Turbo HD DVR V4.30.101 build191120

Release Note

Firmware Basic Information V4.21.000 build 190722	Firmware Version:	V4.30.101 build191120
	SDK Version:	V6.0.2.5_build20190105
	Onvif Version:	V2.2
	Player:	4.81mini
	Play Library (PlayCtrl.dll)	7.3.5.0
	Web component:	V4.0.1 build 190920
	IVMS-4200:	2.7.1.51

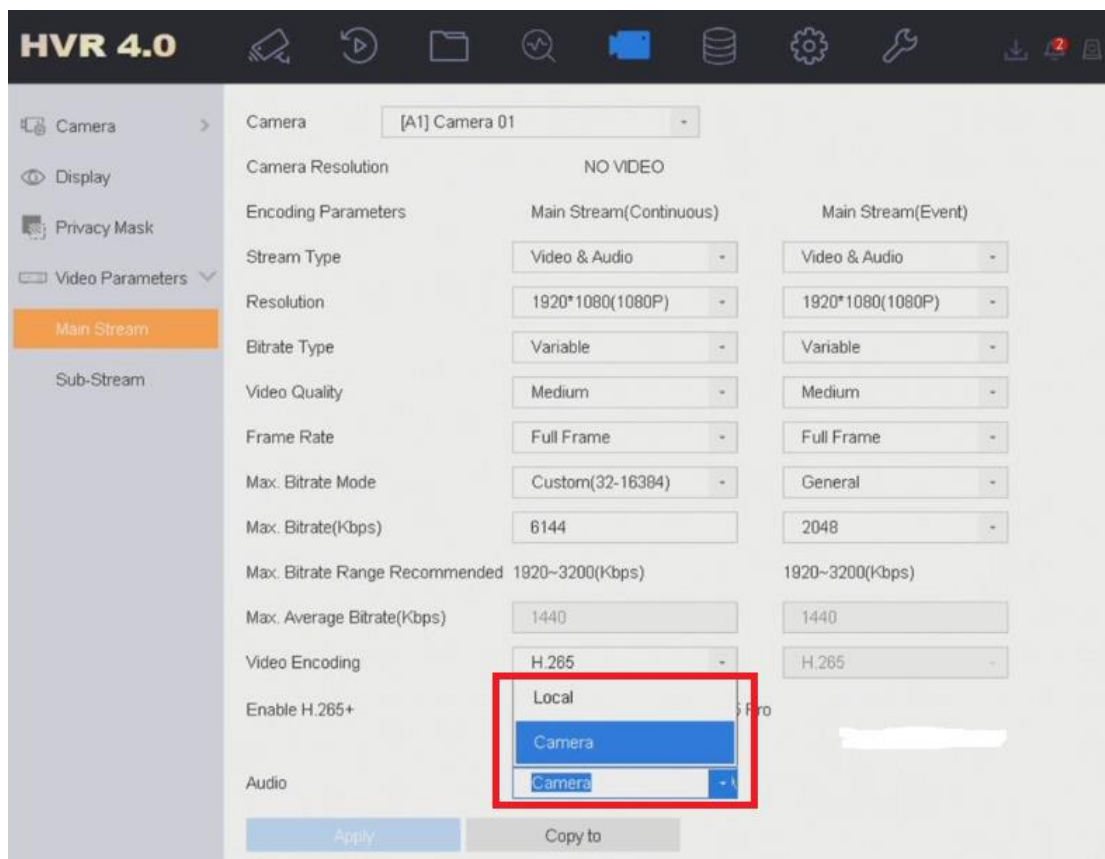
Models that support coaxial-audio, you can see the word “(S)” in the expanded information section of the label.
